Appendix C: Alternative Route Selection Correspondence

Riverside x Strachan Underground Cable Replacement

Assessment of Proposed Route Alignments by City of Toronto

Assessment Segment 1: Parkside Drive to Roncesvalles Avenue approx. 660 m (Figure 1)

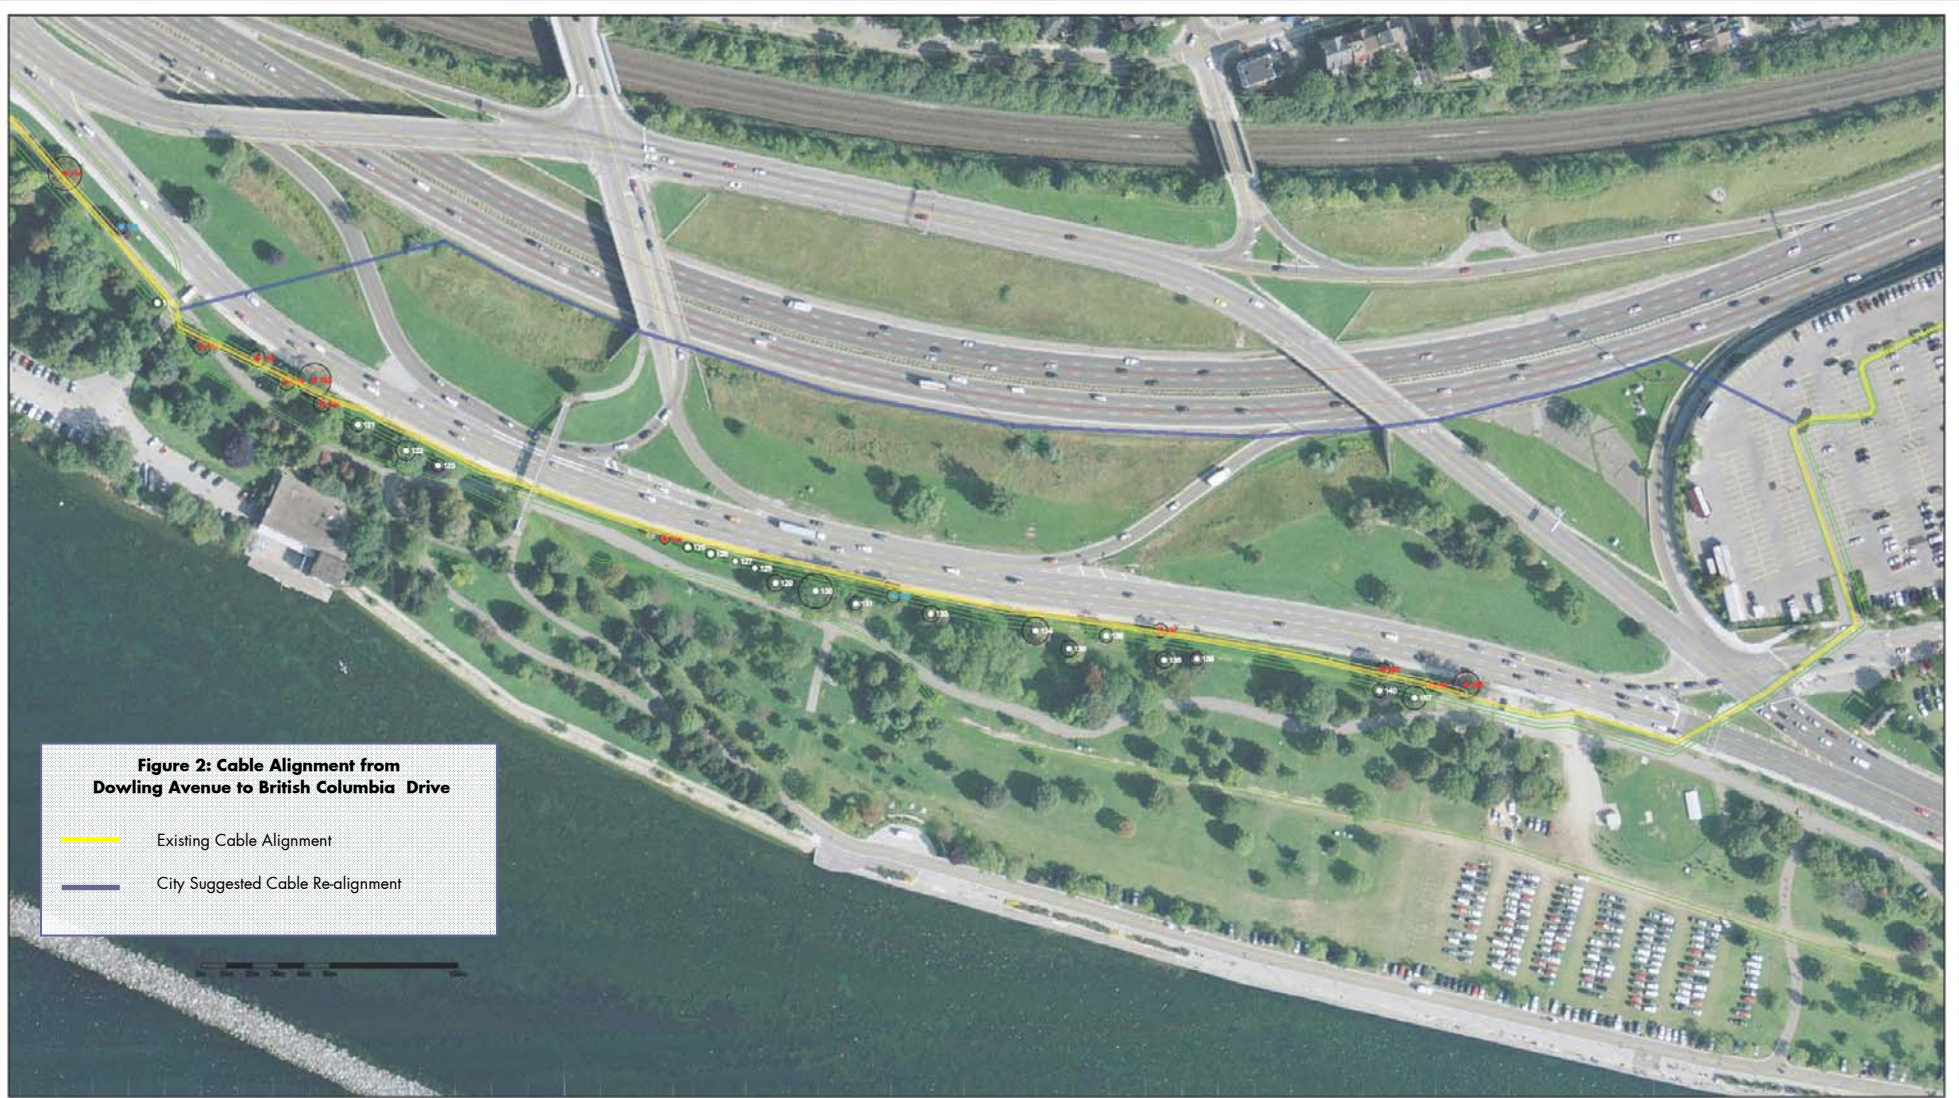
The existing cable route is in the median of Lake Shore Blvd West between the westbound and eastbound lanes.

City of Toronto proposed route: Grass area north of Lake Shore Blvd West westbound, south of Gardiner Expressway

- Proposed area is in public road allowance – may be same as existing
- Length of the route is comparable to the existing.
- Number of road crossings is the same; however, a diagonal road crossing is needed here, i.e. it is longer and hence more costly.

- Grass area is very narrow and already occupied by Bell, Toronto Hydro, storm sewers, water main, City's pump station, and high mast lighting.
- Some utilities observed in the field, not shown on TPUCC drawings.
- Number of utility crossing is less than existing route; however, this may change once missing utilities are inserted on TPUCC drawing.
- In certain areas particularly close to high mast lightings, there seems to be no room for Hydro One new duct bank.
- The new duct bank may need to be installed under the pavement in some parts or all.
- Lane closures will be needed during construction.

- Requires additional 4 – 5 months of engineering to finalize the centre line in consultation with the City, revise, and circulate and feedback/changes to TPUC drawings.
- The existing H2JK ca2 does not need to be removed.
- Additional engineering and construction cost (traffic control and restoration) due to installation under the road is expected to exceed cost savings of not removing the cable by approximately \$1M.

- On grassed strip would remove approximately 2-4 fewer trees
- Most trees on strip are immature
- Re-alignment retains more mature tree including tree 90
- If on pavement would remove approximately 13 fewer trees

- Grass strip or north lane would likely cause similar traffic disruption during construction. Anticipated that a lane closure is required in part or whole
- Northern lane would require further disruption when restored

- Place the alignment in the southern lane of the westbound Lake Shore Blvd. to avoid all of the utilities known to be in the grassed area
- This location
 - best reflects the current cable location from a technical perspective
 - meets Hydro One's acceptable time risk tolerance
 - eliminates the removal of any trees
 - meets the City planning objective(s)
 - reduced traffic issues because the median can be used
 - possible cost sharing with City

Figure 2: Cable Alignment from Dowling Avenue to British Columbia Drive

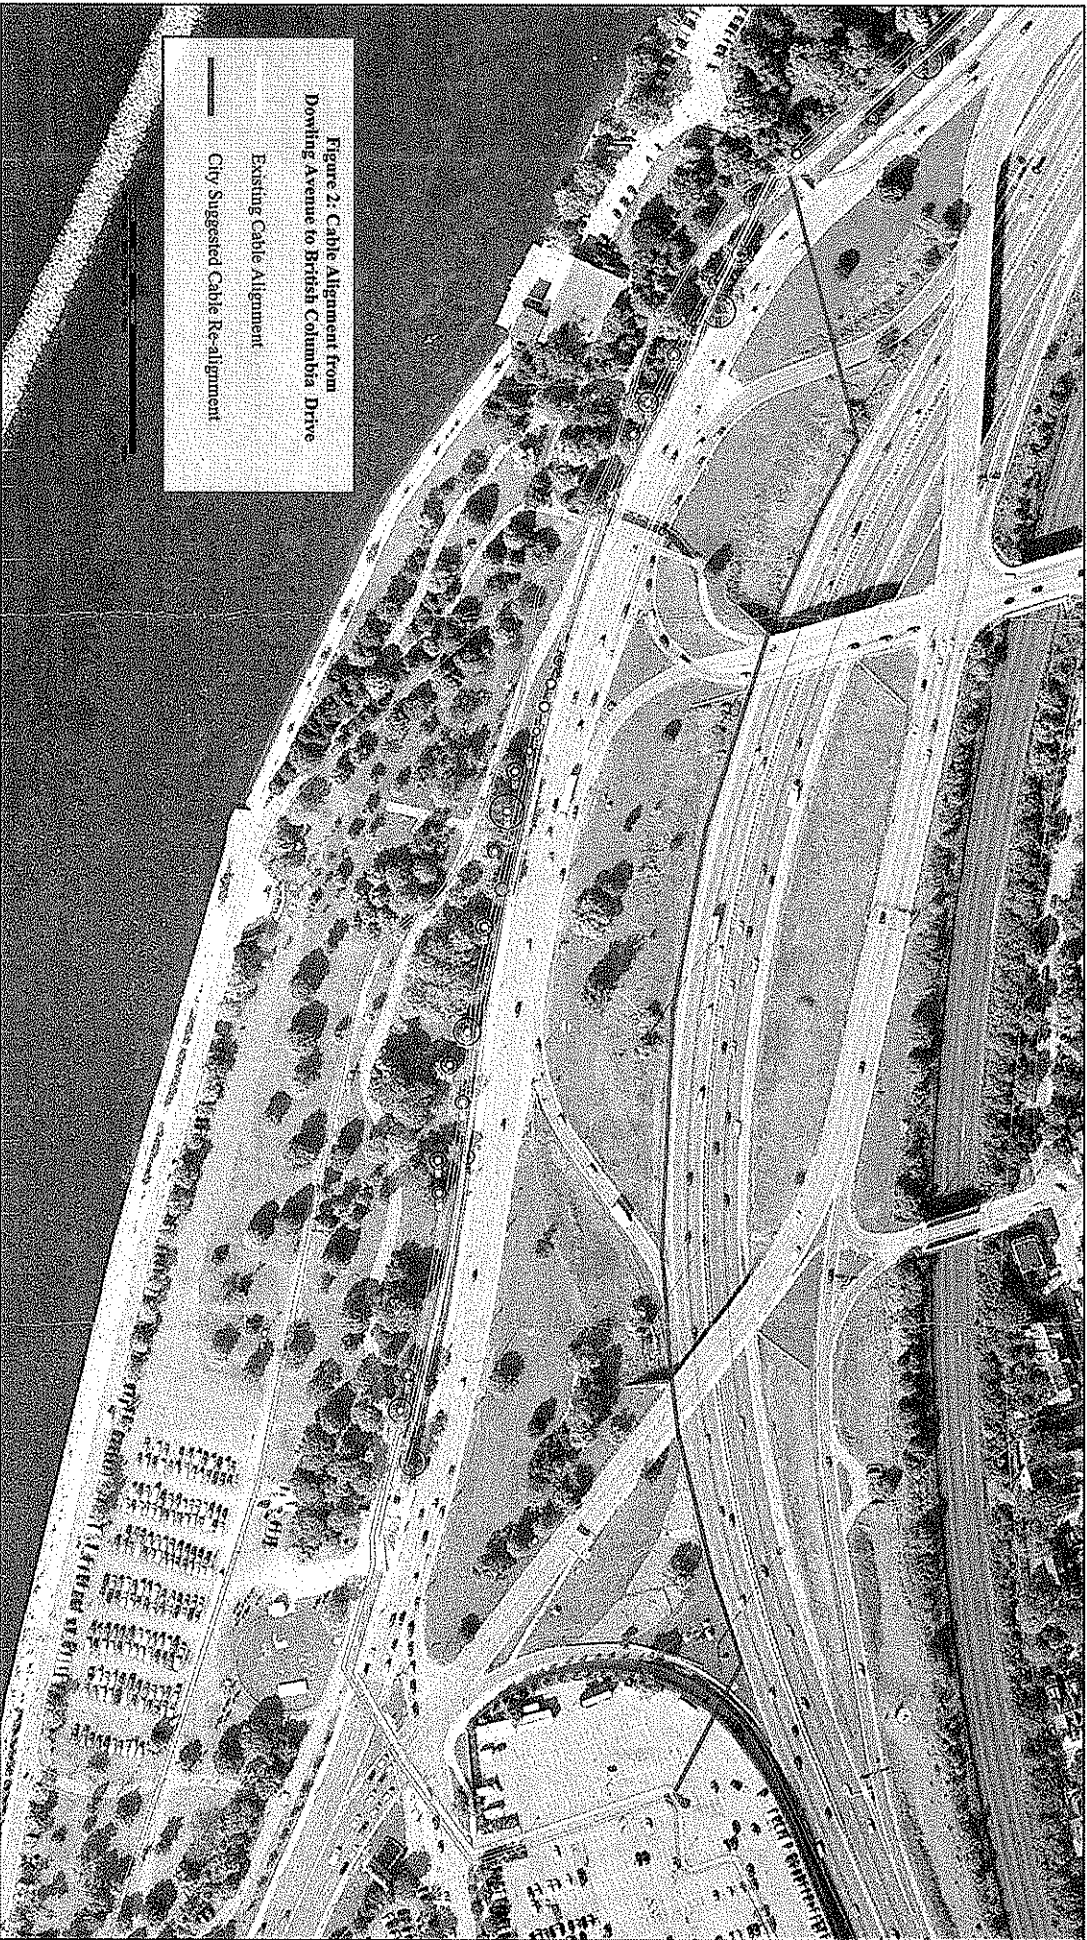
Existing cable route: South of Lake Shore Blvd West eastbound.

City of Toronto proposed route: Mainly just south of Gardiner Expressway

- Proposed area is in public road allowance.
- Length of the route is may be shorter between 100 to 150 m depends on where the final centre line would end up,

- Number of road crossings is 6 (two abandoned, four active), as opposed to one road crossing in existing route.
- Two road crossings require crossings with two concrete base bridges and/or the closing of GE lanes.

- The proposed route is on steep land. Extensive earthwork required to allow for installation. May require remedial measures to shore Gardiner Expressway

- Engineering suggests we should seriously consider a tunnel in this area due to major grade changes, uncertainty about future grade changes in this area and bridge crossings.

- Access roads need to be installed during the construction and possibly for maintenance.
- TPUCC drawings show other utility installations just north of Lake Shore Blvd westbound away from the proposed route. This is possibly to avoid additional construction cost associated with adverse grades.

- Number of utility crossing seems to be more than existing route.
- Additional soil thermal resistivity tests are needed in the new route.
- Survey plan needs be prepared showing all infrastructures, and grading to determine the centre line because of grade changes.

- Additional engineering efforts are needed to finalize the centre line using survey plan and in consultation with the City.
- Hydro One TPUCC drawings need to be revised and circulated to other utilities for feedback/changes

- Approx. engineering time needed to do all above: 6 to 8 months. If a tunnel is required further delays would be expected.
- The existing H2JK ca2 do not need removal.

- Additional engineering and construction cost is expected to far exceed the current estimate by \$2 M to \$4 M (no tunnel). This figure must be revisited once a centre line is established and engineering solution is determined.

- No advantages with respect to tree retention

- To stay on existing route.
- Anticipated time delay is very conservative and could be as much as 12 months

- Cost increase is also conservative and represent more than a 10% budget over run without considering the need for a tunnel
- Hydro one management does not support the time delay because of the poor condition of the cable. This delay could jeopardize the reliability of supply to Toronto
